**NOTICE OF MEETING
PLANNING & ZONING COMMISSION
TUESDAY, MAY 5, 2026
T.W. "TURK" CANNADY – CEDAR HILL ROOM
CEDAR HILL GOVERNMENT CENTER
285 UPTOWN BLVD. – BLDG. 100
CEDAR HILL, TEXAS 75104
6:00 P.M.**

RE: Case No. FP-781-2026 (Final Plat – Milotte Margaret Estates, Lots 2R, 3R-1, and 3R-2, Block 1)

FINAL PLAT
BALCONES RANCH
PHASE 1
125.961 ACRES
238 RESIDENTIAL LOTS, 28 HOA LOTS & 2 CITY LOTS
MARCH 25, 2026
FP- -2024

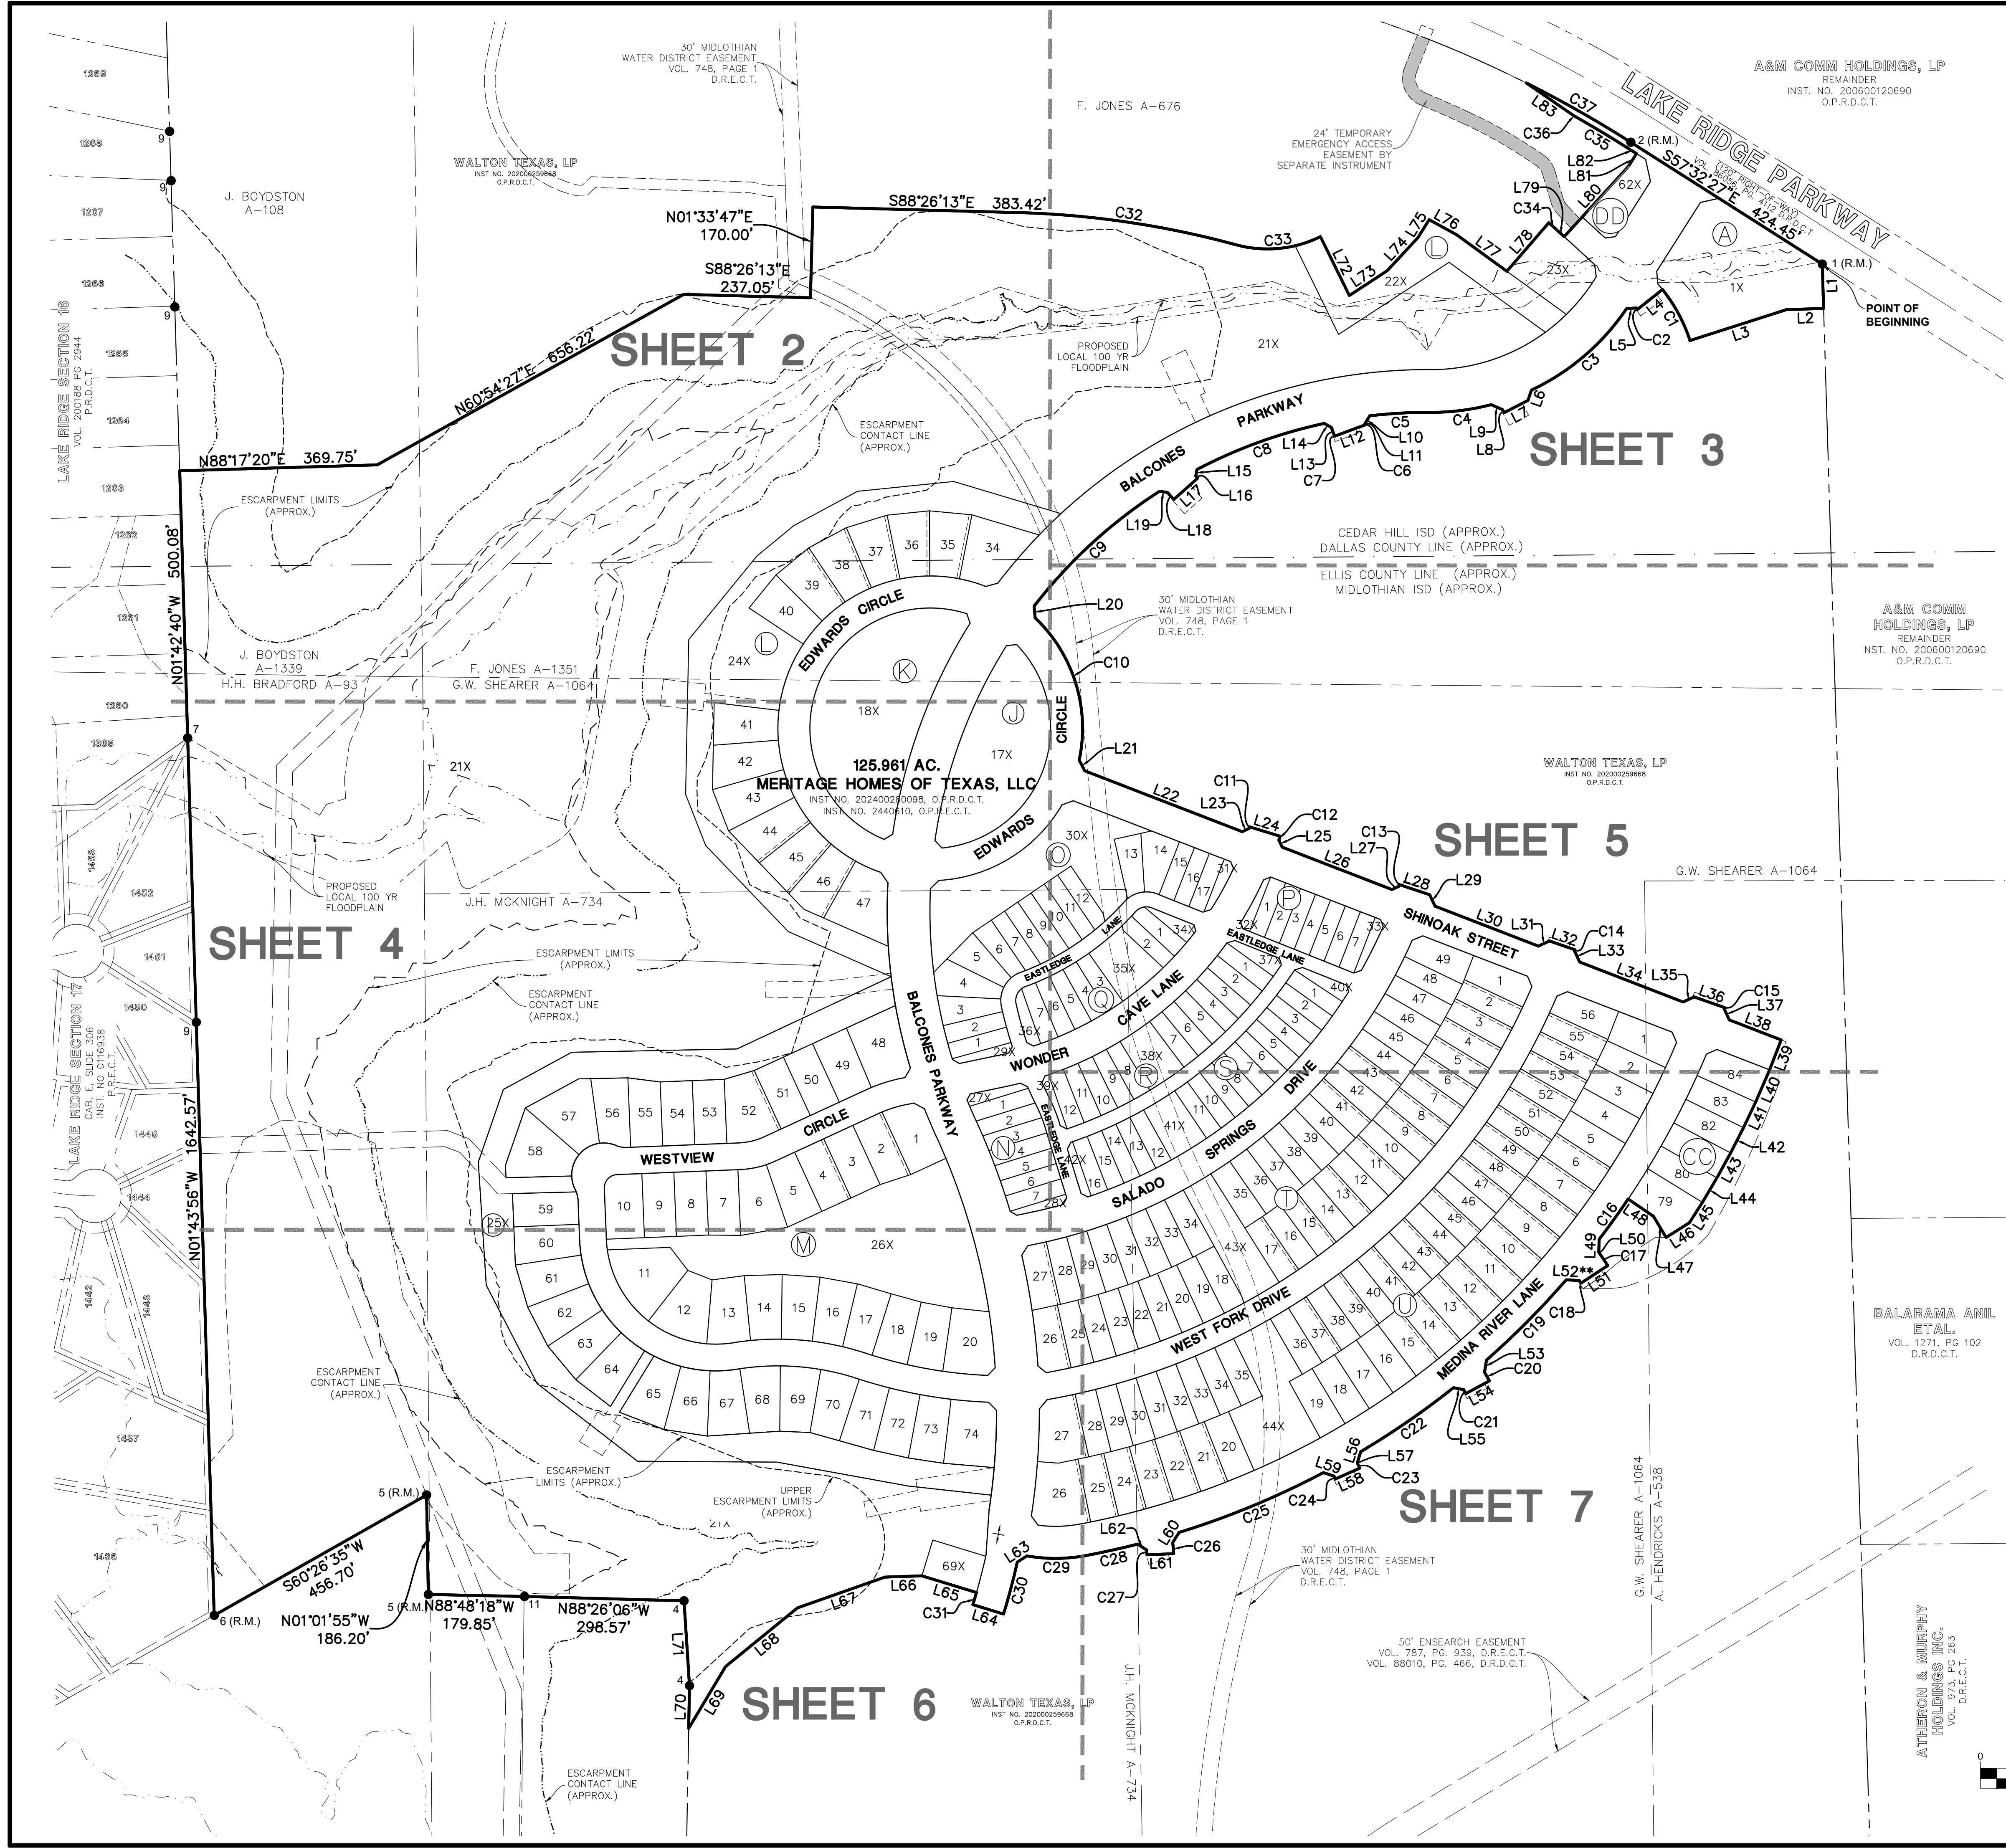
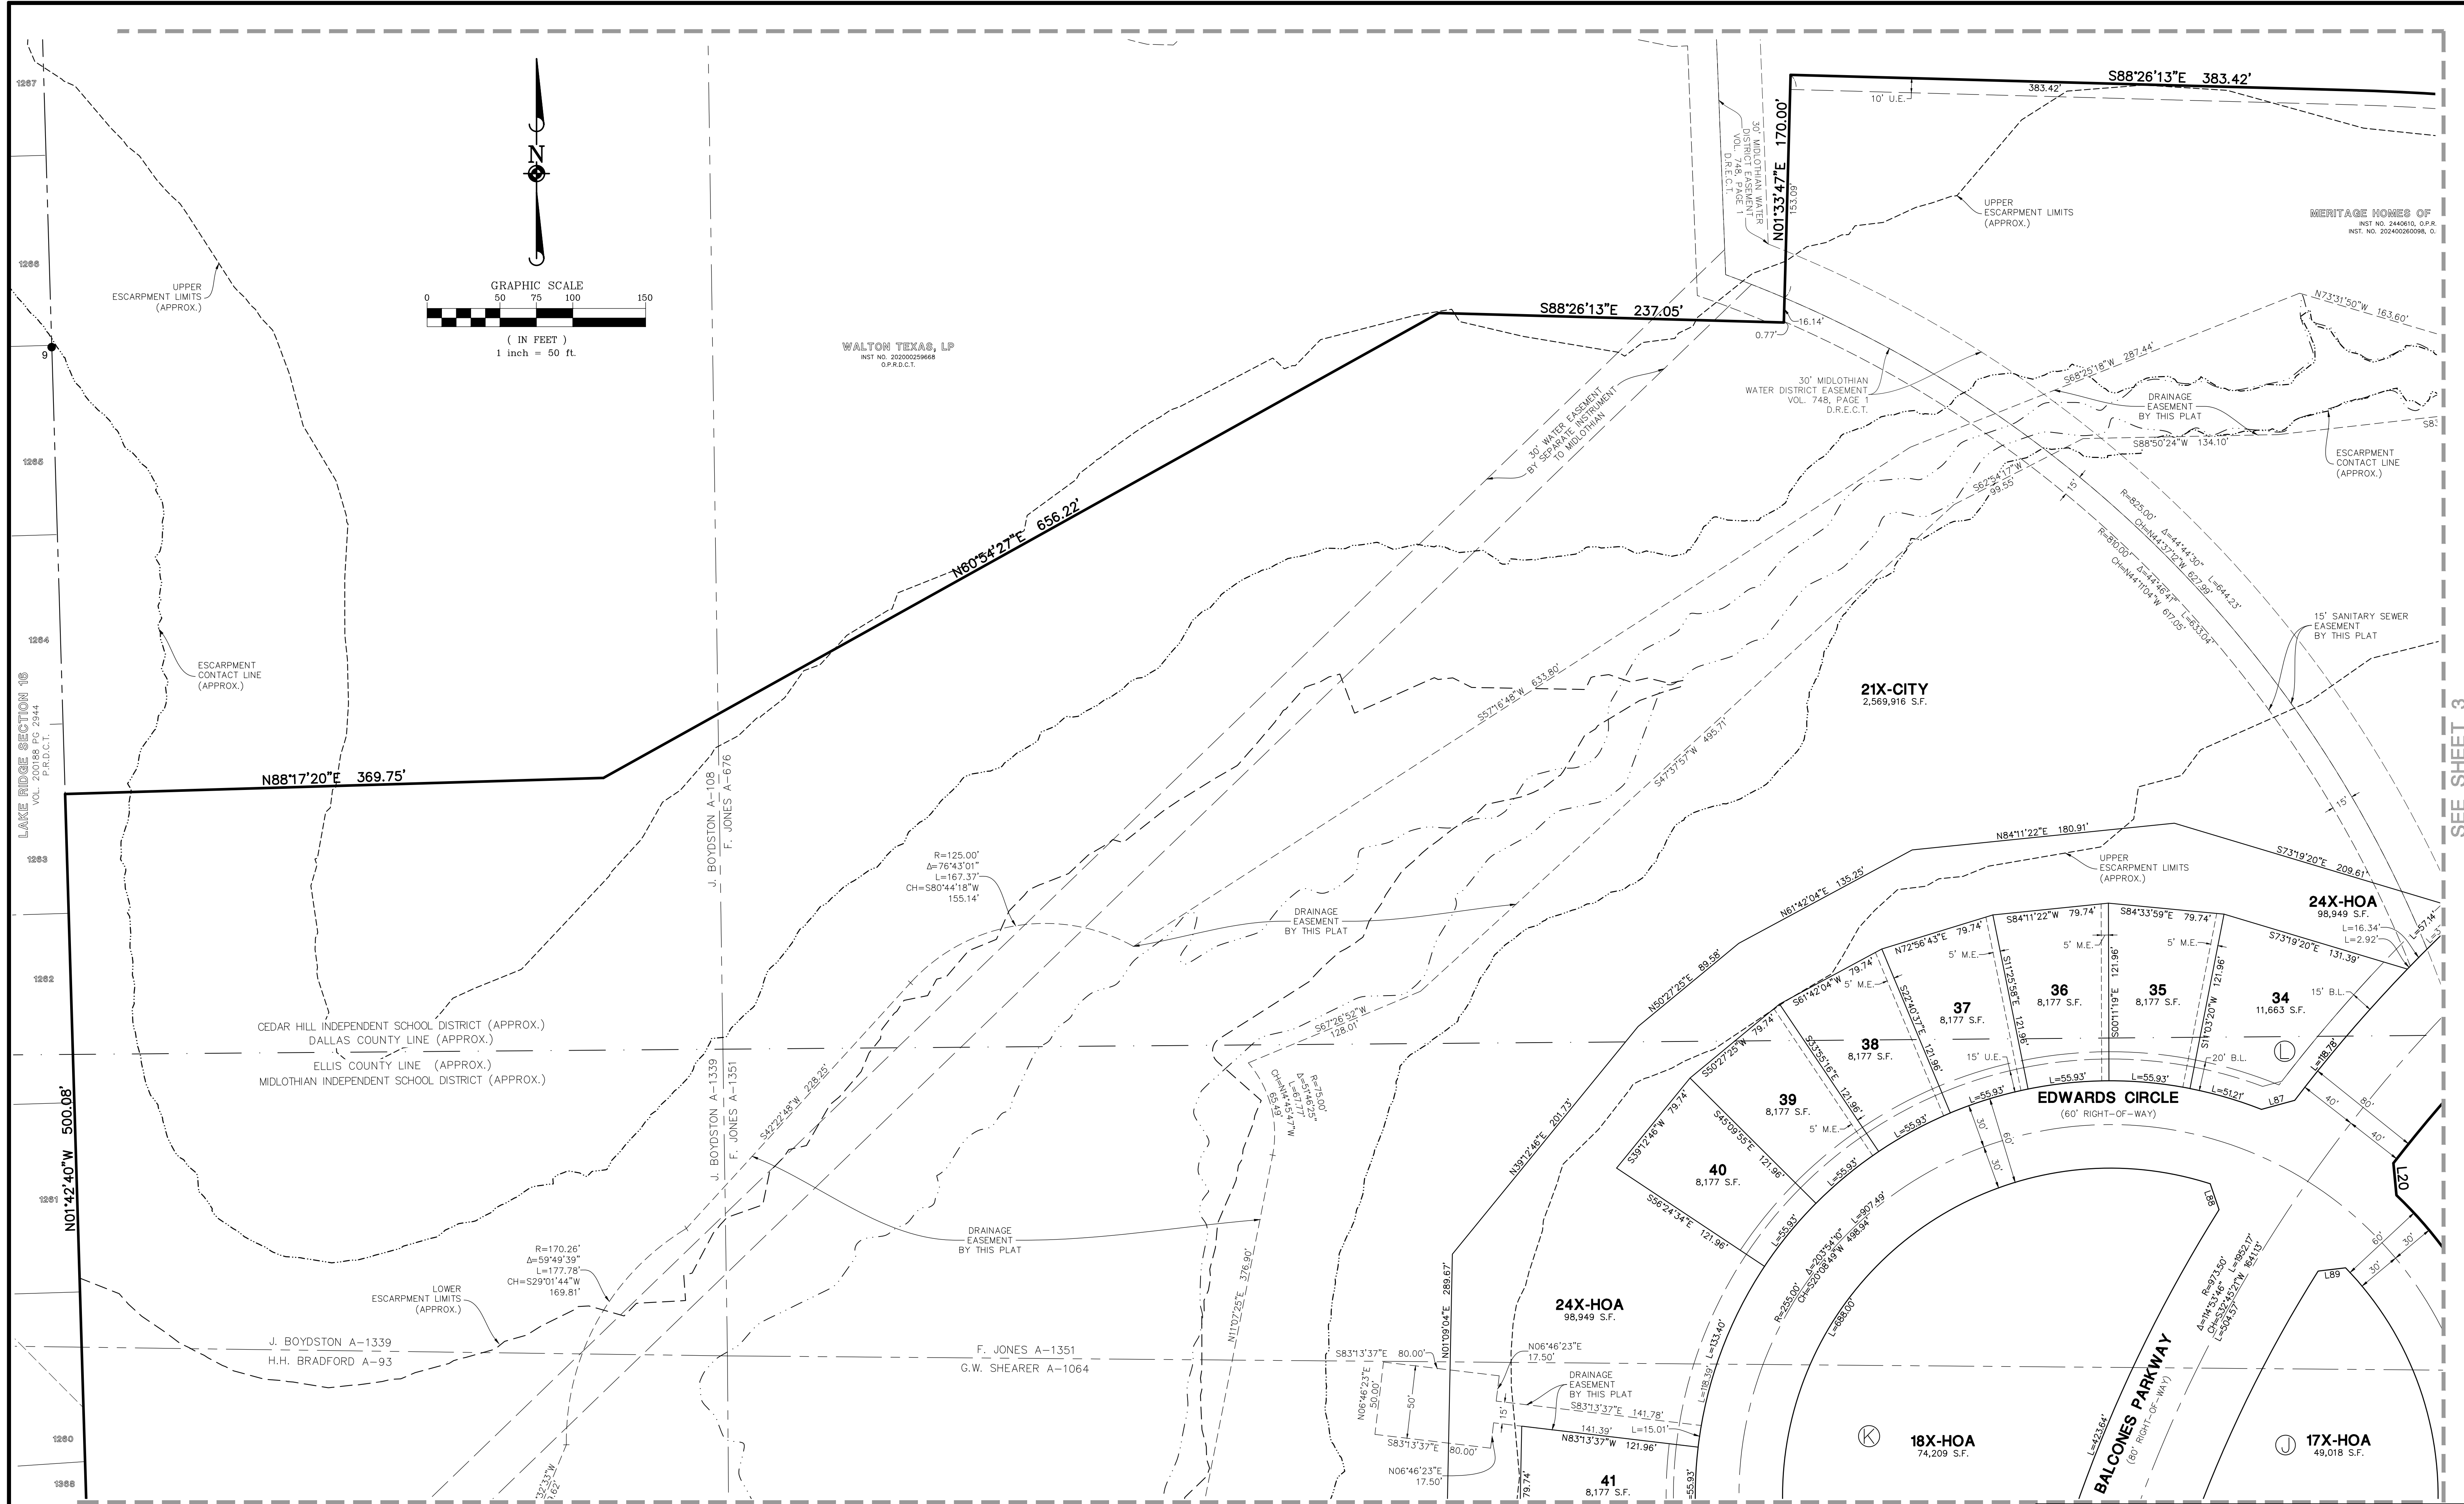
Planning Department	Code Citation
<p>1. Provide evidence of plat distribution to the applicable franchise utility companies.</p> <p>Simply send them an email to the applicable contacts, and copy the City and with the following: <i>"On behalf of the (applicant's name), we are submitting a final plat at (address) for a residential subdivision of 238 lots in Cedar Hill, Texas. If you have any questions, please contact me and/or the applicant."</i></p>	<p>Chapter 20, Section 20-11(c)(1) thru (9) of the Subdivision Regulations</p>
<p>2. Provide approval from the Post Office regarding the proposed residential subdivision layout PRIOR TO RECORDATION of the Final Plat.</p>	<p>Chapter 20, Section 20-11(c)(9) of the Subdivision Regulations</p>
<p>3. Provide a certified copy of the owner association agreement and association by-laws where required for maintenance prior to the recordation of the plat.</p>	<p>Chapter 20, Section 20-11(b)(21)(b) of the Subdivision Regulations</p>

<p>4. Add case no. FP-782-2026 underneath the Title Block.</p>	
<p>5. This property is within both Dallas County and Ellis County. Staff contacted both Counties requesting requirements for the recording of this Plat.</p> <ul style="list-style-type: none"> • Ellis County response – plat must meet both Texas Property Code for recording and TLGC. Plat sheet size must be 18"x24". • Dallas County response – plat must clearly show/delineate both Counties. Typical Plat sheet size is 24"x36", but they will accept 18"x24". <p>Contact each county directly to confirm and revise sheet layout as needed.</p>	<p>See the attached County correspondences</p>
<p>6. Provide the following note on the plat. "Selling a portion of this addition by metes and bounds is a violation of the Subdivision Regulations and State law and is subject to the withholding of utilities and building permits."</p>	<p>Chapter 20, Section 20-2 of the Subdivision Regulations and TLGC, Section</p>

212.004
7. Remove all building lines and/or yard setback lines and call outs from the proposed plat. Add the following note on the plat. "Building setbacks shall comply with the Zoning Ordinance at the time of the Building Permit."	Chapter 20, Section 20-11(b)(9) of the Subdivision Ordinance

8. Provide the bearing and distance information for all proposed easements.	Chapter 20, Section 20-11(5) of the Subdivision Ordinance
9. Label all existing and proposed easements.	Chapter 20, Section 20-11(b)(5)c of the Subdivision Ordinance

10.The table listing the residential lots and the HOA/Open Space lots has missing lot numbers. Please revise.	Chapter 20, Section 20-10.b(8) of the Subdivision Ordinance

11.Provide the recording information for all proposed off-site easements and/ or easements not by this plat, on this plat prior to the recordation of the plat.

12. Revise the Title Block to separate how many acres are in Dallas County and Ellis County. Add "Addition" to the Title Block and under "Dedication".	Chapter 20, Section 20-11(b)(11) of the Subdivision Regulations; Chapter 20, Section 20-11(f) of the Subdivision Ordinance

13.Per PD, A minimum of 10% of the total 30' / 40' / 50'/ 60 -ft lots with the property may be allowed no more than 5% reduction in area due to site constraints. Verify and confirm.	PD No. 2024-813 Section 10

14. Provide an exhibit that overlays the following information on a plat layout to confirm the maintenance easement locations on this plat: a. all the retaining walls required per engineering plans b. all the fences/screening walls required that will be owned and maintained by the HOA per Section 10.O of PD-2024-813. c. all the maintenance easements associated with walls and fences listed above.	Chapter 20, Section 20-11(b)(19)

15. Remove the telephone and email address from plat.	
16. Add "By this plat" to all proposed plats and add "Dedicated by this plat" to all city properties.	
17. Label all HOA lots on all sheets	
18. Confirm that the meets and bounds does not have to be separated per county property.	
19. Add the Title within the Meritage Homes of Texas Organization for Frank Su under the Dedication Certificate.

Parks Department	Code Citation
1. Park Land Dedication per PD Ordinance has been satisfied. The park development fee of \$700 per dwelling unit will be required. The developer is constructing a 10-foot concrete city trail that is approximately 3,300 linear feet with Phase 1 infrastructure improvements. The developer may utilize this fee requirement for the construction of this trail. Please provide a cost estimate (OPC) for the construction of this trail.	Chapter 20, Section 20-42(c) & Section 20-43(a) of the Subdivision Regulations
2. Provide 10-ft Trail Easements for the trail sections that cross HOA lots.

Public Works Department	Code Citation
1. Provide Northern and Easterlings for at least two corner pins for reference in city GIS system.	Chapter 20, Section 20-11(b)(3) of the Subdivision Regulations
2. Please remove the escarpment limits and contact line from the Plat. However, a note shall be added that the escarpment exists and that there is a plan associated. This shall comply with the City Ordinance and the escarpment plan.	Chapter 20, Section 20-75(c) of the Subdivision Regulations
3. Please indicate that City lots are being dedicated by this Plat.	
4. Please add a note stating any changes in the approved grading plans shall be submitted to the city.
